## **ALERT SERVICE BULLETIN**

**412-20-184**

**MODEL AFFECTED:** 412EP

**SUBJECT:** CIRCUIT BREAKER PANEL P/N 412-589-101, INSPECTION OF.

Figure 1 - Correct INV 1/PWR bus symbol.

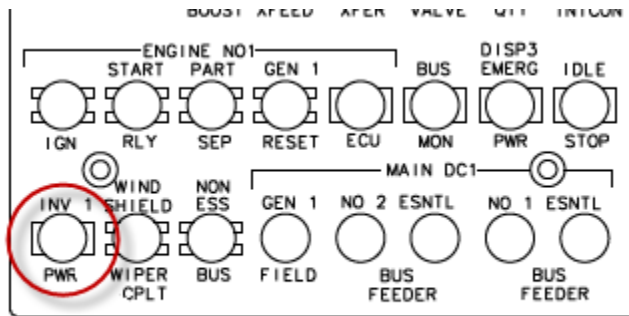
Bell has discovered that some left-hand overhead circuit breaker panel assemblies 412-589-101 may have the inverter number 1 power (INV 1/PWR) bus incorrectly identified. In some cases, the symbol shows the INV 1/PWR as being on the “Essential Bus” while it should show the symbol for the “Emergency Bus”.

1. Prepare the helicopter for maintenance.
2. Disconnect the helicopter battery.
3. Inspect the left-hand circuit breaker panel. The INV 1/PWR circuit breaker should be identified as shown in Figure 1. Figure 2 shows the incorrect bus symbol.

4. If the INV 1/PWR circuit breaker is identified as shown in Figure 1, go to step 10, otherwise proceed with the following steps.
5. Remove mounting screws (2, Figure 3) from circuit breaker panel (1). Retain the screws for future use.
